REMARKS

Amendment Under 1.111
10/642,653

FIG. 7
PRIOR ART

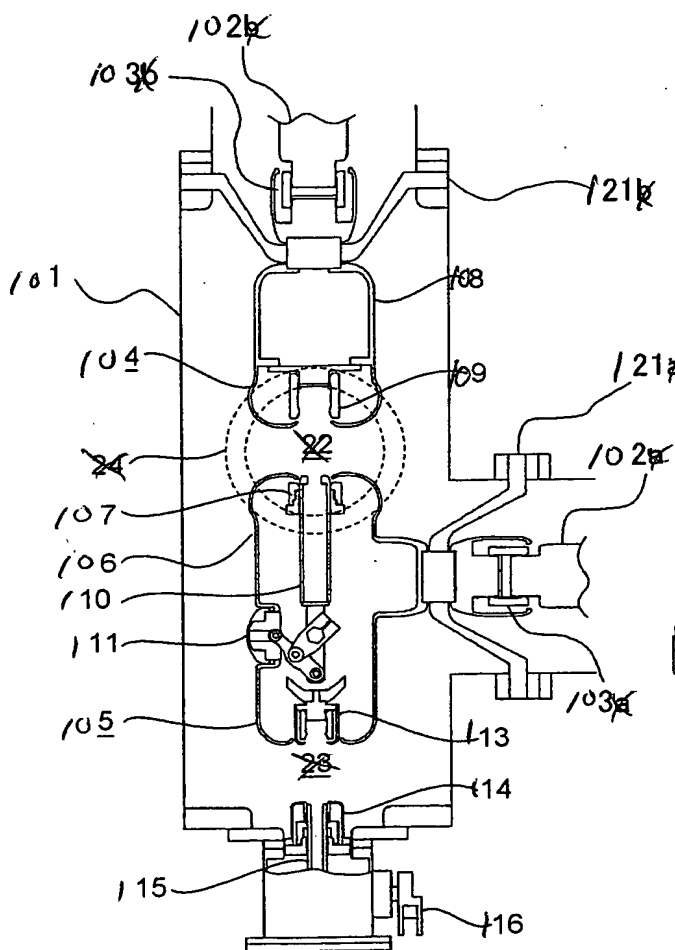
The drawings are also objected to as failing to comply with 37 C.F.R. § 1.84(p)(4) because the reference character “12” has been used to designate both an “insulation support” at page 1, line 28 and a “contact” as page 6, line 11. Similarly, the reference character 11 has been used to designated both a “first operating mechanism” at page 1, line 24 and a “contact” at page 5, line 24. The Examiner notes that there are additional reference numerals with similar dual uses in the drawings.

Finally, Applicants also note that the prior art figures 7 and 8 include numerals related to structures that are not defined or otherwise mentioned in the portion of the specification dealing with the prior art. In particular, elements 21a, 21b, 22, 23 and 24 are not mentioned in the text at pages 1 or 2. Thus, these pages have been rewritten (1) consistent with a change in the reference numerals for Figs. 7 and 8 and (2) in order to add a description of the structures related to structures 21a and 21b, and to remove reference numerals 22, 23 and 24 from the Figures as they are not necessary to understand the invention. Again, no new matter has been added.

Upon Applicants’ review of the figures, it appears that the same numerals were used in the description of the prior art (Figs. 7 and 8) to describe structures that are different from those that apply to the invention (Figs. 1-6). This practice is confusing and, accordingly, Applicants have made an amendment to Figs. 7 and 8, using different reference numerals. In particular, Applicants now have adopted a technique of using a “100” series of numerals for the figures that illustrate the prior art. Thus, the tank in Fig. 7 (currently 1) has been given the numeral 101. Similarly the operating mechanism (currently 16) has been given a numeral 116. The first and second electrodes have been designated as 102 and 103. Applicants’ proposed amendment is submitted herewith. Appropriate amendments to the specification also have been made. No new matter has been added.
